Report on Review of Bay Delta Conservation Program Modeling

Since December 2012, MBK Engineers and Dan Steiner (collectively “Reviewers”) have assisted various parties in evaluating the operations modeling that was performed for the Bay Delta Conservation Plan (BDCP). To assist in understanding BDCP and the potential implications, stakeholders¹ requested that the Reviewers review the CalSim II modeling studies performed as part of the BDCP (hereafter “BDCP Studies” or “BDCP Model”).

This Report summarizes: (1) the Reviewers’ independent analysis and review of the BDCP Model, publicly released for the BDCP’s Draft EIR/S in December 2013, (2) the Reviewers’ updates and corrections made to the BDCP Model, and (3) comparisons between the original BDCP Model and the independent Model as revised by the Reviewers.

Figure 1. Projected Inflow to Trinity, Shasta, Oroville, and Folsom Reservoirs – NAA, NAA-ELT and NAA-LLT

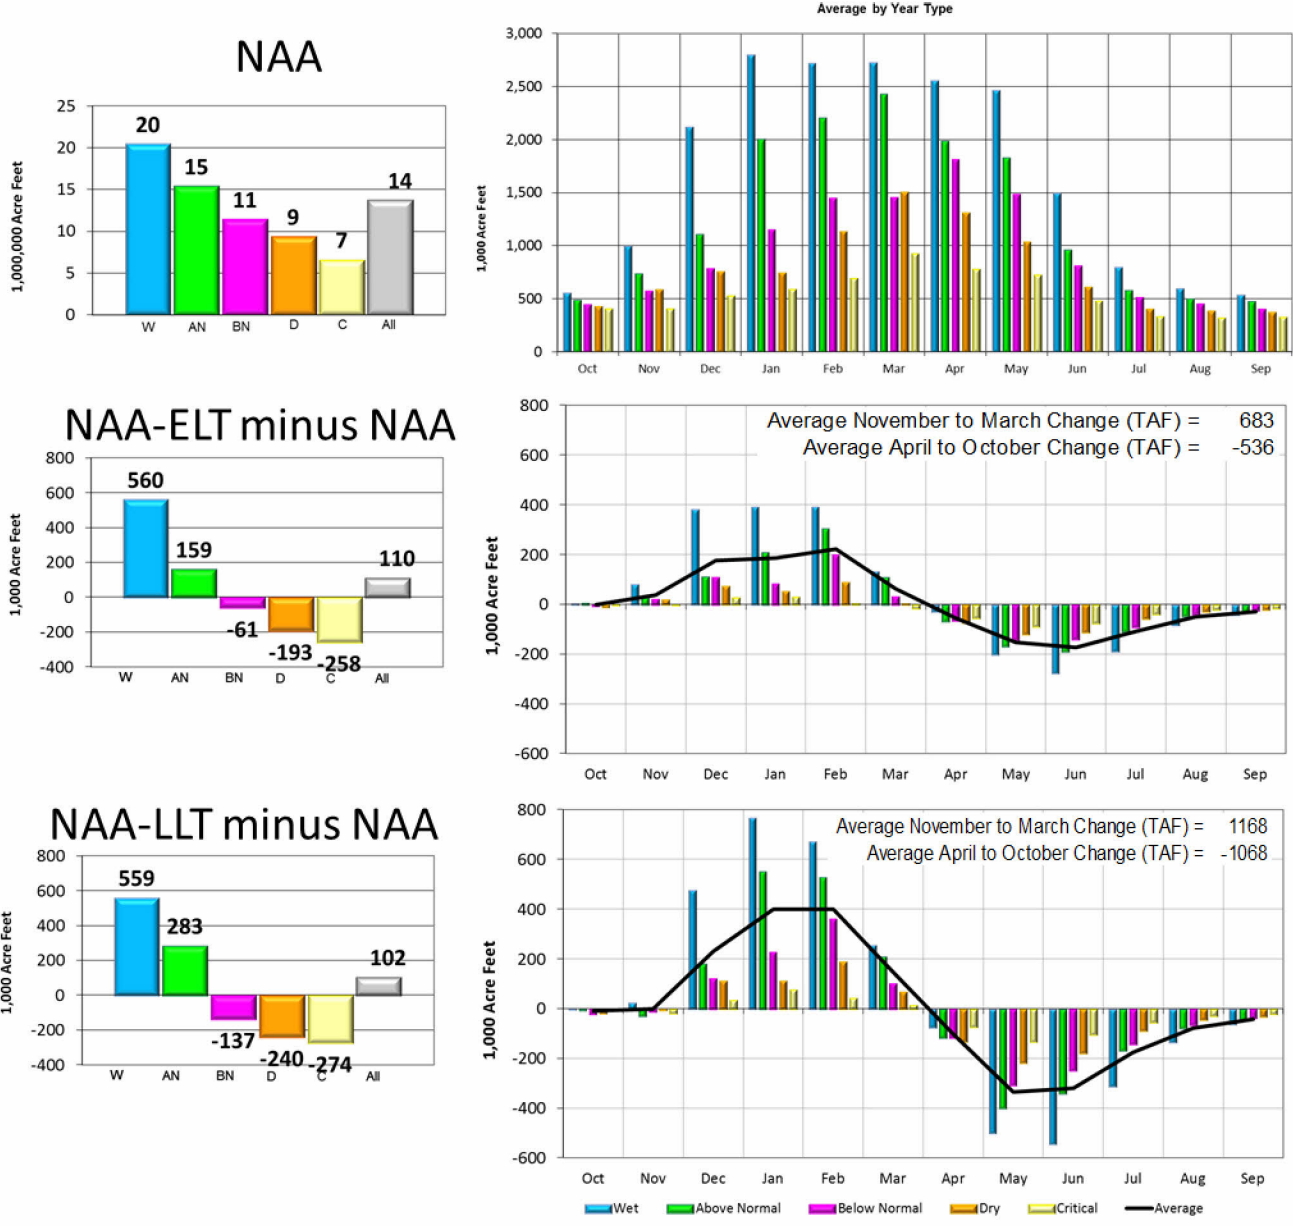
The significance of changed hydrology between the three without project baselines is illustrated in Figure 1 below. The figure illustrates the projected combined inflow of Trinity, Shasta, Oroville, and Folsom Reservoirs under the three NAA baselines. Numerous modeling projections for climate change have been developed, and in this BDCP group of Scenarios Trinity, Shasta, and Oroville inflow are projected to increase overall, but with a

In our opinion, the CalSim II depicted operations that incorporate climate change are not reasonably foreseeable and do not represent a likely future operation of the CVP/SWP. Although an argument is typically made that these study baselines will be used in a comparison analysis with Project Alternatives tiering from these baselines, we believe that the depicted operations do not represent credible CVP/SWP operations and we have no confidence in the results and they are inappropriate as the foundation of a Project Alternative. As such, although the modeling approach may provide a relative comparison between equal foundational operations, we are apprehensive to place much confidence in the computed differences shown between the NAA and Project Alternative Scenarios.

Figure 2. Projected Shasta Reservoir Carryover Storage, NAA, NAA-ELT and NAA-LLT

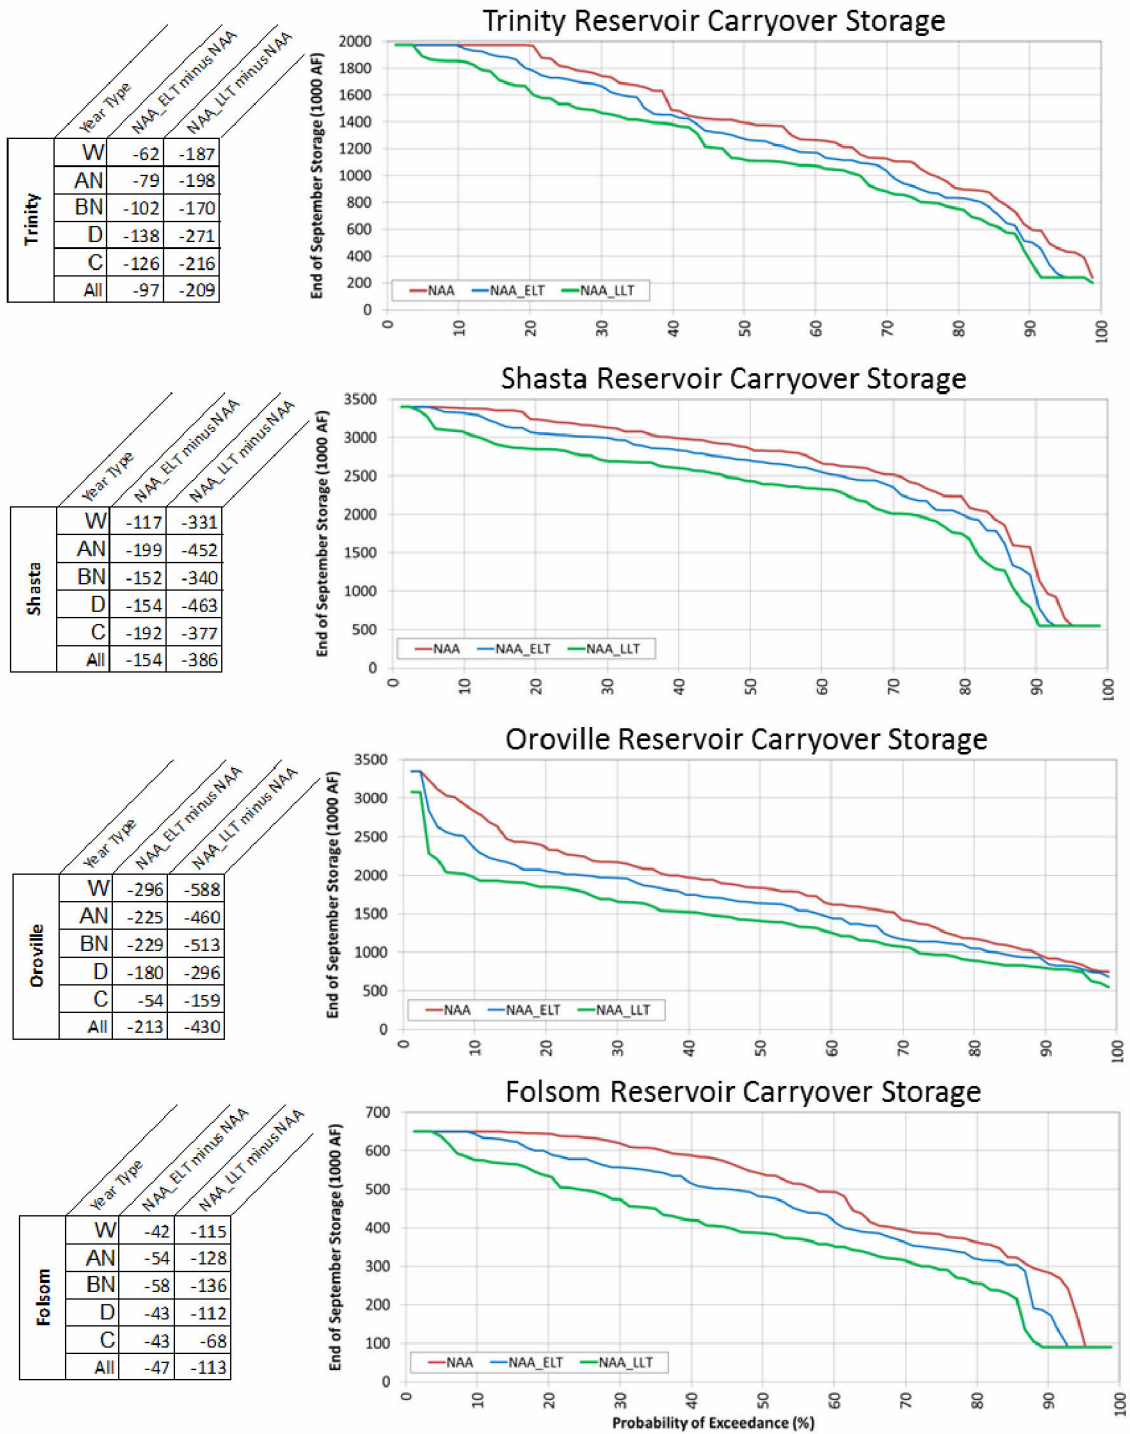
For upstream CVP and SWP reservoirs the assumed shift of inflows due to climate change (Figure 1) along with a continuing need to satisfy exports demands significantly affects carryover storage. The CVP and SWP simply cannot satisfy water demands and regulatory criteria imposed on them in the NAA-ELT and NAA-LLT modeling scenarios.

Figure 2 illustrates the typical change in carryover storage as shown for Trinity, Shasta, Oroville, and Folsom Reservoirs. The relatively high frequency (approximately 10% of time) of minimum storage occurring at CVP reservoirs illustrates our questioning of credible operations in the studies.

Figure 3. Projected Inflow to Millerton Lake –NAA, NAA-ELT and NAA-LLT

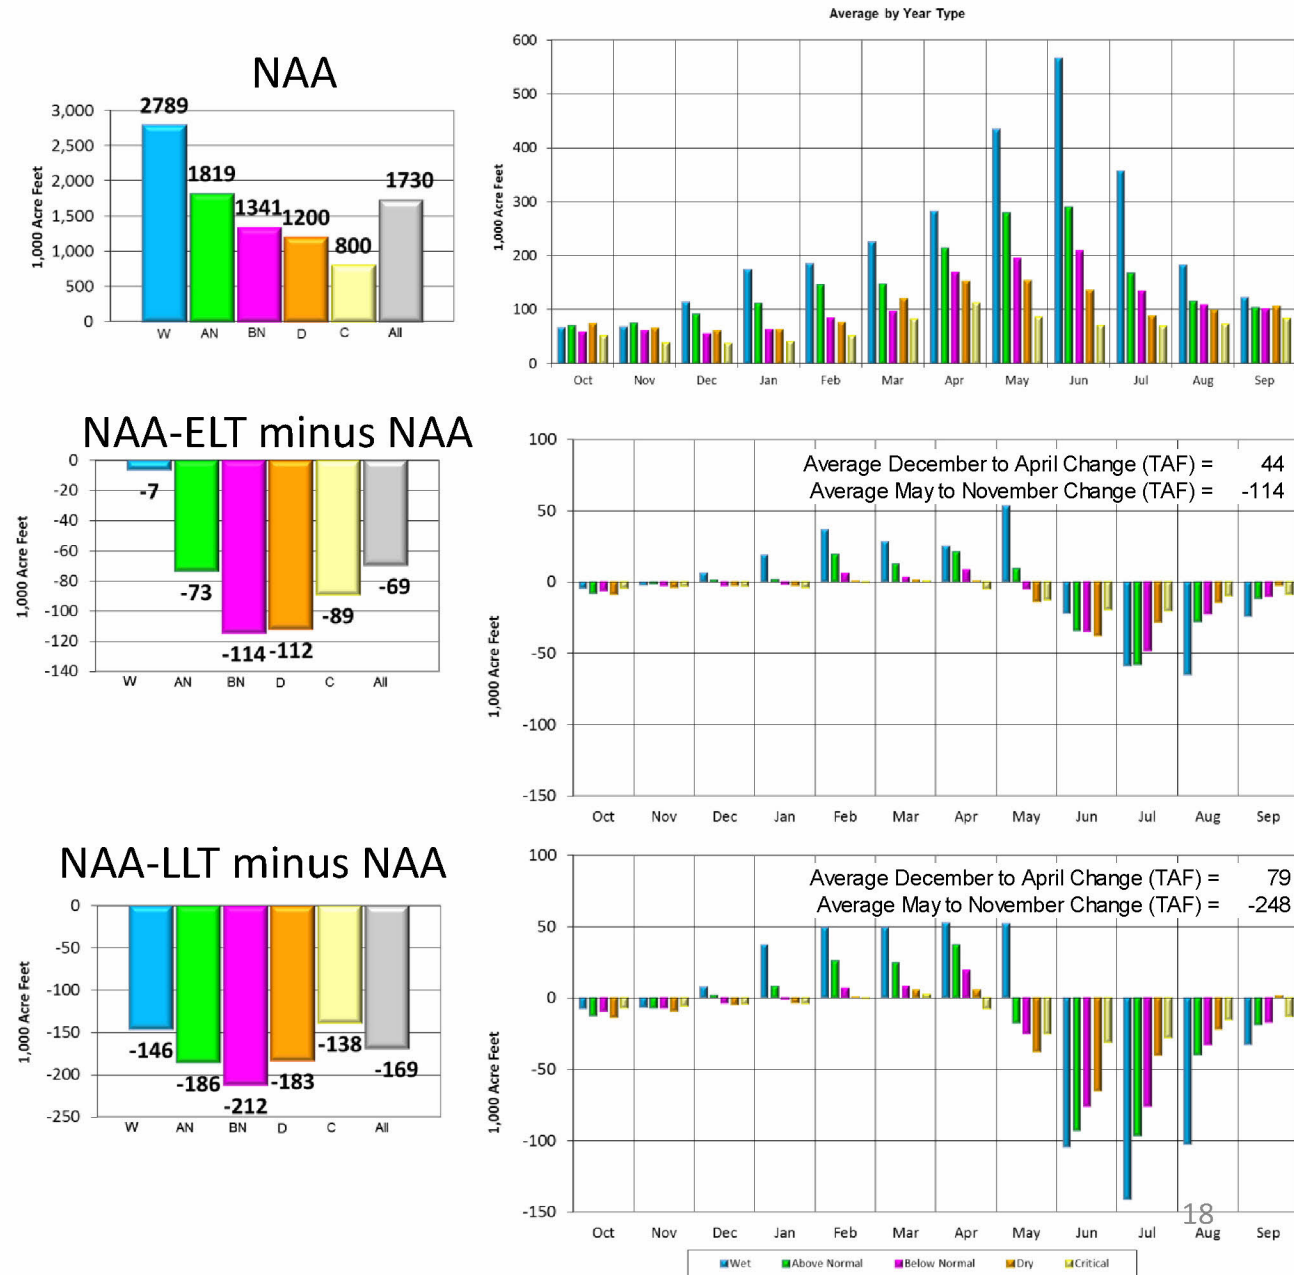
San Joaquin Valley reservoirs are depicted with an overall decrease in annual runoff with some shifting of runoff from spring to winter, but mostly just decreases in spring runoff due to a decline in snowmelt runoff during late spring⁵. Figure 3 illustrates the assumed effects of climate change upon inflow to Millerton Lake.

The hydrology differences imposed in the NAA Scenarios of the Friant Division are described above, and its appropriateness may be subject to additional debate and Alternative assumptions. However, our review found that implementation of Millerton Reservoir inflow as affected by climate change was improperly performed.

Inflow to Millerton Reservoir in this version of CalSim is input in three separate time series for purposes of depicting the hydrology of potential upper basin reservoirs. Climate change hydrology was inconsistently incorporated at Millerton Reservoir and misapplied to the water supply and flood control operations. The result is an unrealistic operation for river releases and canal diversions. Figure 3 illustrates the projected ELT and LLT changes in Millerton Reservoir inflow incorporated in these studies. On face value of the input data, regardless of Friant Dam river release assumptions the effect of climate change at Millerton Lake will affect water deliveries.

Figure 4. Millerton Reservoir Carryover Storage, NAA, NAA-ELT and NAA-LLT Scenarios

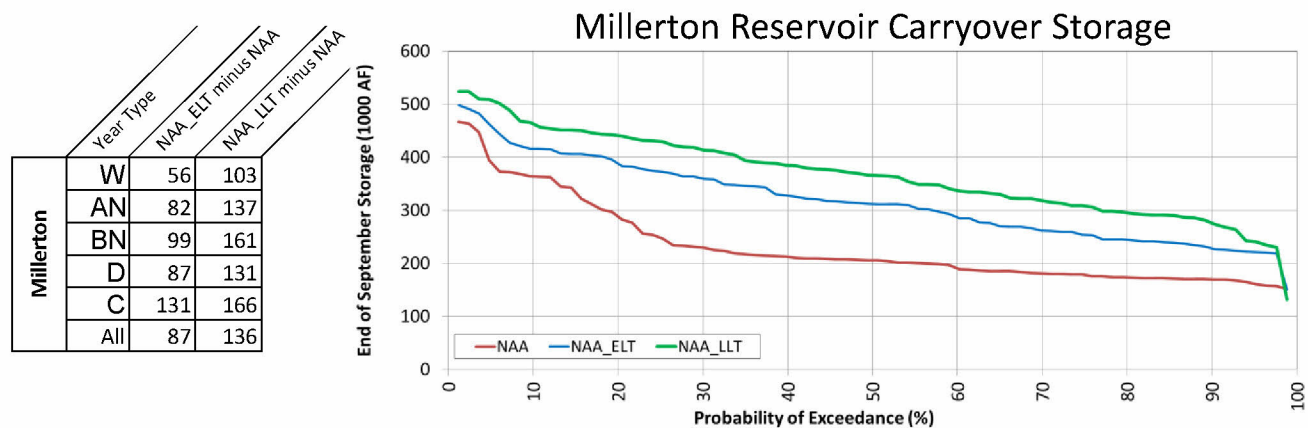
Evidence of the inconsistent inflow problem is shown in the result for the comparison of carryover storage of Millerton Reservoir under the NAA, NAA-ELT, and NAA-LLT Scenarios (Figure 4). Carryover storage is higher in the ELT and LLT Scenarios due to climate change effects to inflow incorporated in reservoir operations but not in the computation of water supply deliveries. Thus, water deliveries are suppressed and the reservoir ends the year with greater storage.

Figure 12. Temperature Exceedance Sacramento River at Bend Bridge Existing, No Action Alternative, ELT

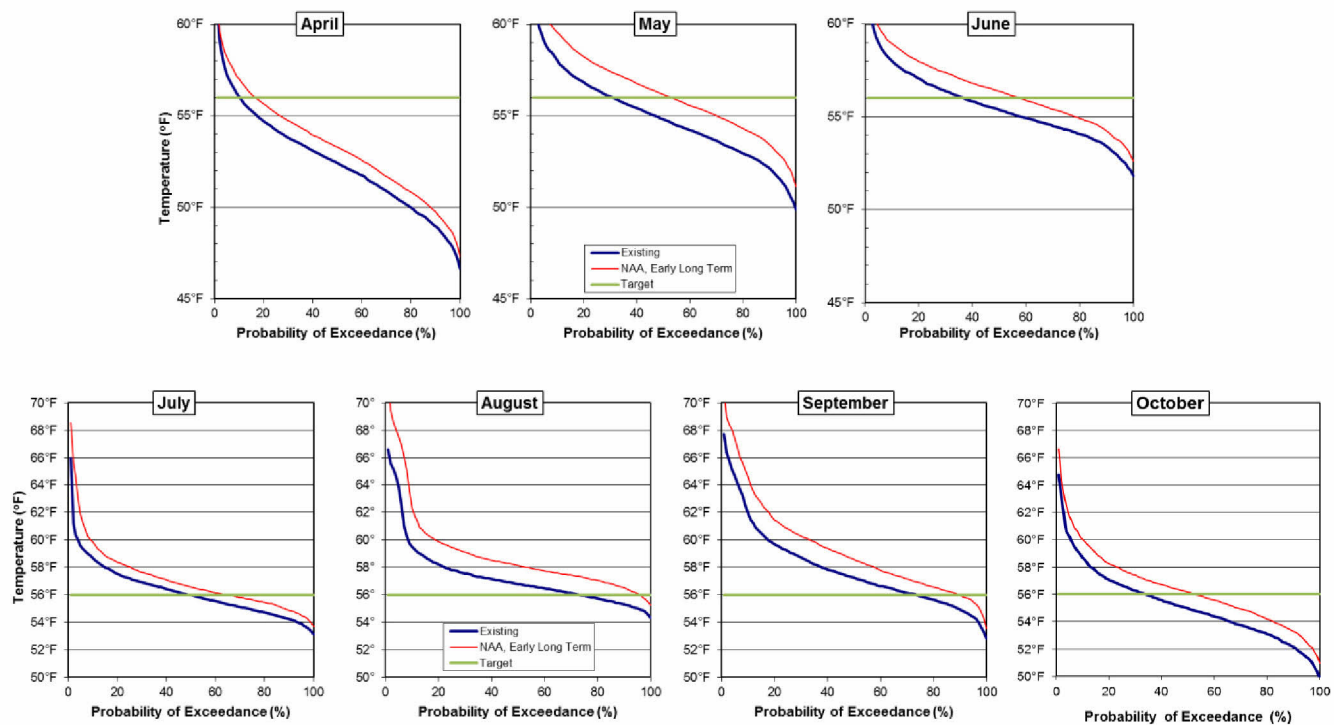
The increase in equilibrium temperatures combined with decreases in storage would lead to water temperature conditions that would likely not achieve the assumed objectives. Figure 12 and Figure 13 illustrate an increase in the probability that a water temperature target of 56°F would be exceeded at Bend Bridge under both the NAA-ELT and NAA-LLT Scenarios. The probability of exceedance increases approximately 5% to 20% depending on the month for the NAA-ELT Scenario and approximately 10% to 40% for the NAA-LLT Scenario.

Figure 19. NDD, Bypass Requirement, Bypass Flow, and Excess Sacramento R. flow for Alt 4-ELT

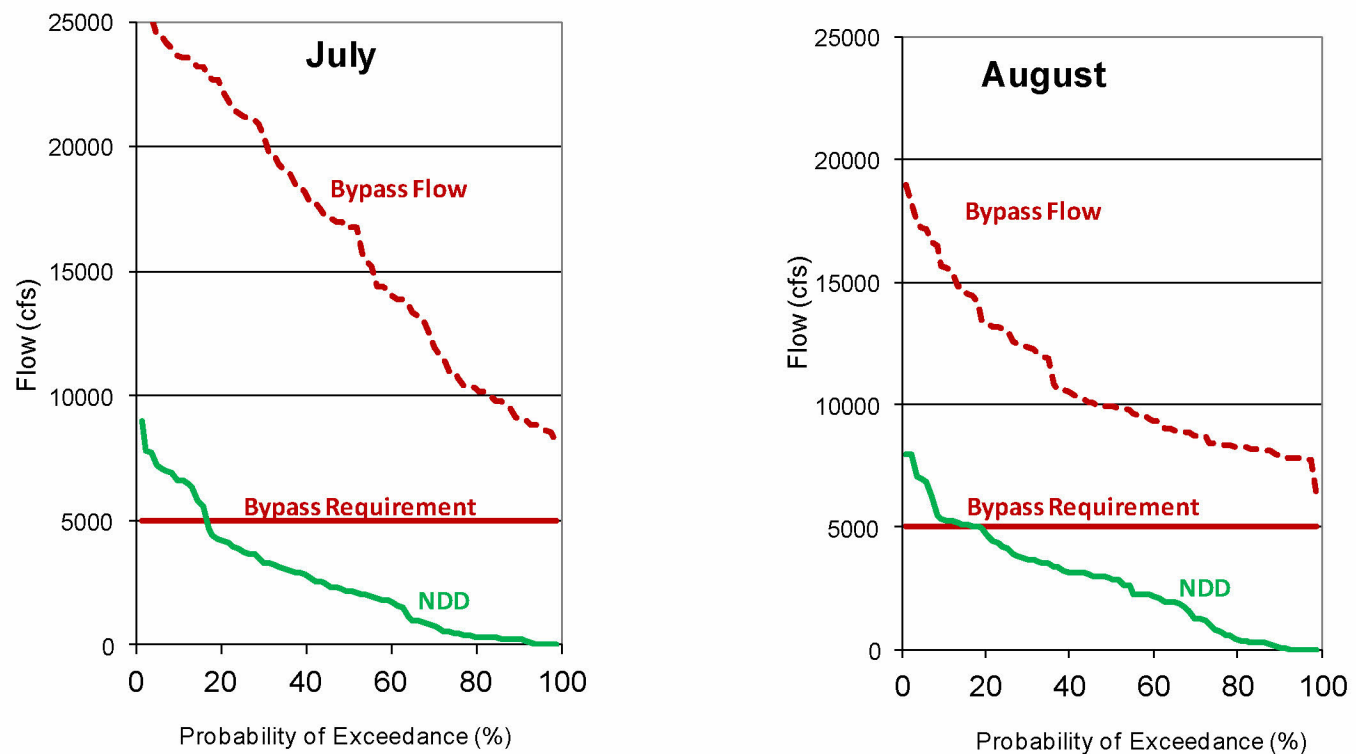
Sacramento River flow below the North Delta Diversion (NDD) must be maintained above the specified bypass flow requirement, therefore the NDD rates are limited to the Sacramento River flow above the bypass requirement. Due to an error in CalSim II that specifies an unintended additional bypass requirement, modeling performed for the BDCP EIRS often bypasses more Sacramento River flow than is specified in the BDCP project description. This error has been fixed in the most recent public releases of CalSim II, but BDCP modeling has not been updated to reflect these fixes. Figure 19 contains exceedance probability plots showing the Sacramento River required bypass, Sacramento River bypass flow, NDD, and excess Sacramento River flow to the Delta as modeling for BDCP. As can be seen in Figure 19, the bypass flow is always above the bypass requirement in July and August. The BDCP version of CalSim sets a requirement for Sacramento River inflow to the Delta needed to satisfy all Delta flow, quality, and export requirements, this requirement should be removed when modeling the NDD.

Figure 22. Alt 4-ELT North Delta Diversion Versus South Delta Diversion for July, August, and September

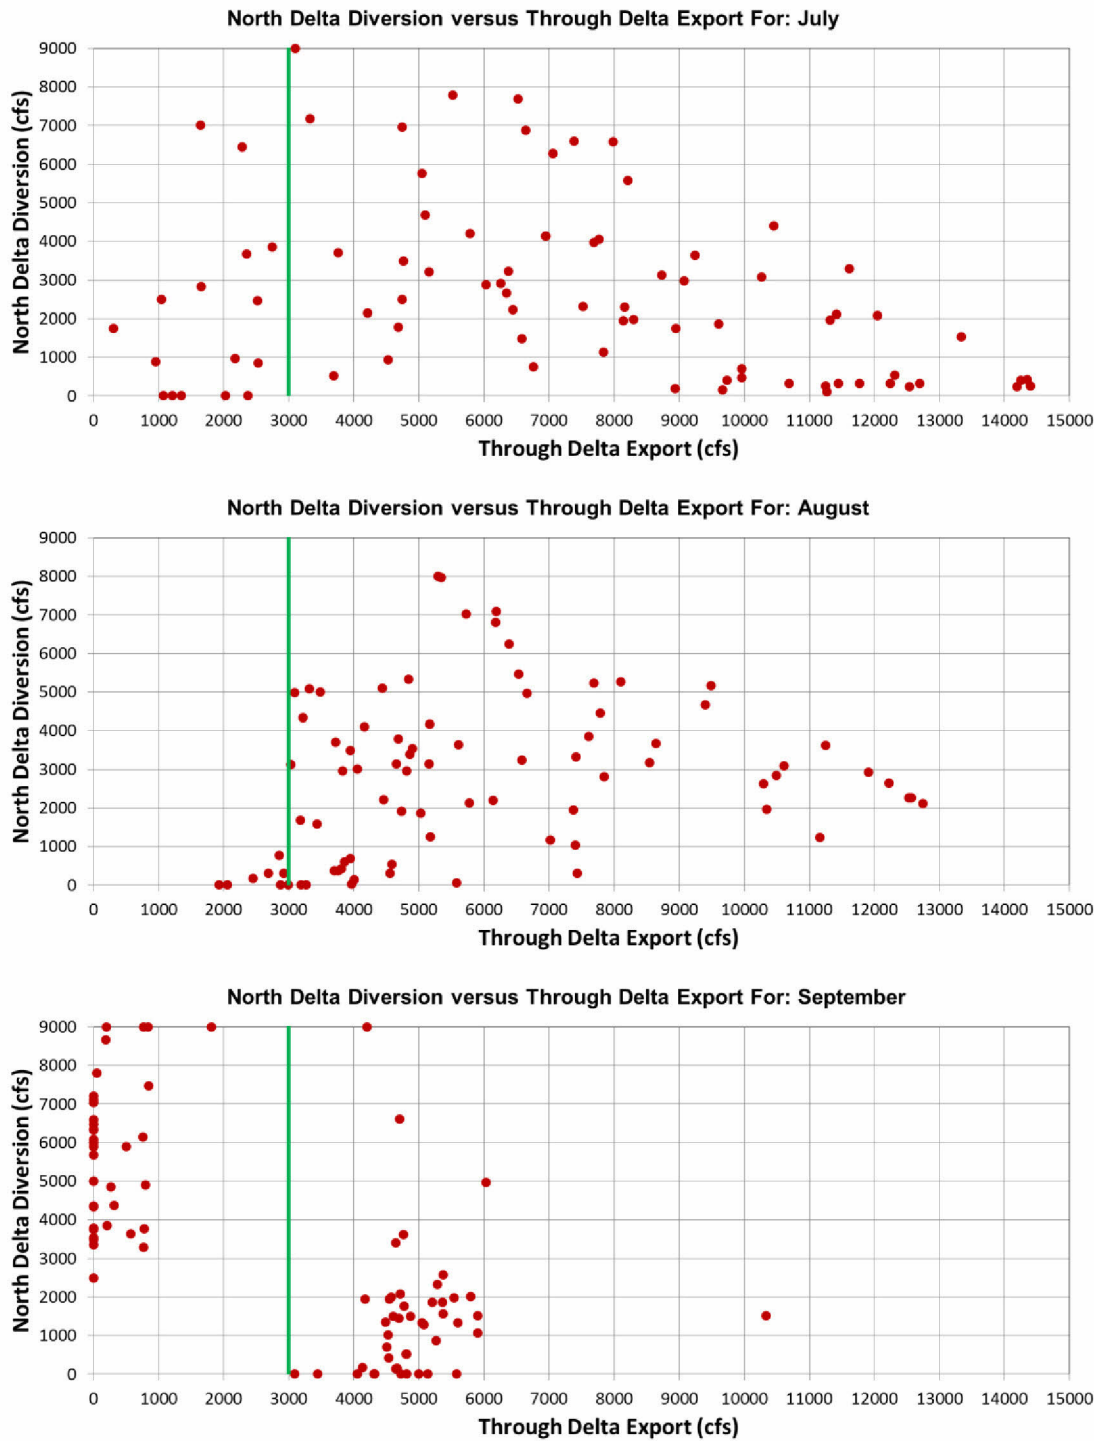
Figure 22 contains figures for July, August, and September for Alt 4-ELT that plot NDD against SDD. In the months of July to September SDD are occasionally very high, exceeding 14,000 cfs in July, with minimal NDD. This occurs due to outdated model code that imposes an instream flow requirement in Sacramento River flow below Hood in excess of the bypass criteria prescribed in the BDCP. There are numerous occurrences when bypass flows prescribed in the BDCP are exceeded and SDD are higher than expected. On the other hand, there are also many times when NDD are above minimum pumping levels and SDD are below the BDCP prescribed 3,000 cfs threshold indicated by the green line in Figure 22. For unknown reasons, the model code requiring SDD to be greater than 3,000 cfs before NDDs occur from July through September is deactivated in the BDCP modeling of this Alternative.
